**MANOR PLANNING & ZONING
COMMISSION MEETING
AGENDA
105 E. EGGLESTON STREET
MANOR, TEXAS 78653
DECEMBER 14, 2016 · 6:30 P.M.**

Re: Stonewater North Subdivision
Fourth Preliminary Plan Application Submittal
City of Manor

Re: Stonewater North Subdivision
Fourth Preliminary Plan Submittal Review
City of Manor

Figure 1
Aerial Map
Manor Commons Area Tract
Located at Highway 290 and FM 973
Manor, Travis County, Texas

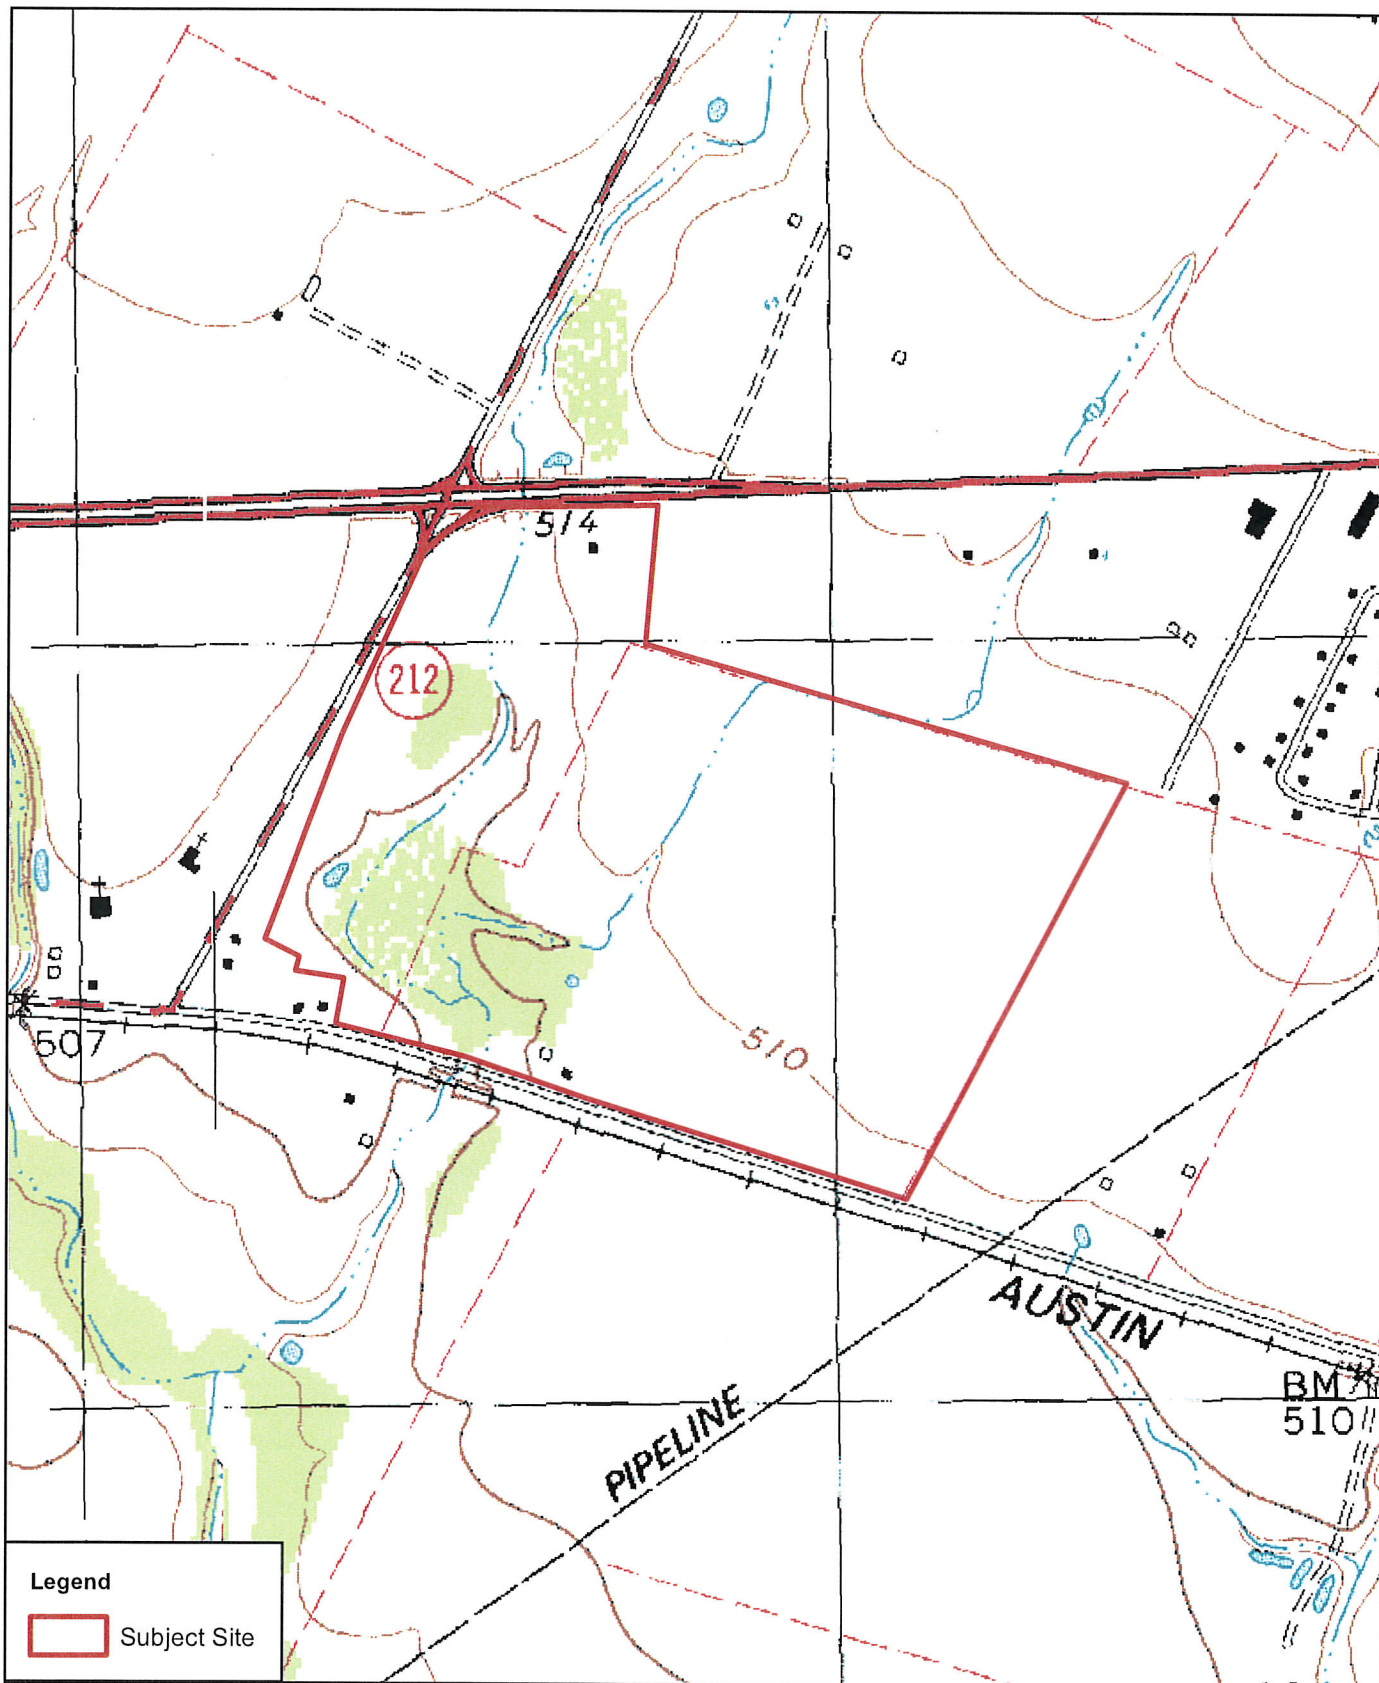
Based on the field investigation and current USACE guidance, Horizon personnel identified unnamed intermittent tributaries of Wilbarger Creek within the subject property (Figure 1). The investigation and data analysis demonstrated that the identified tributaries exhibited an ordinary high water mark (OHWM) and were hydrologically connected to a Traditional Navigable Waterway (TNW) (Colorado River), therefore meeting the requisite criteria to be classified as a jurisdictional waterway.
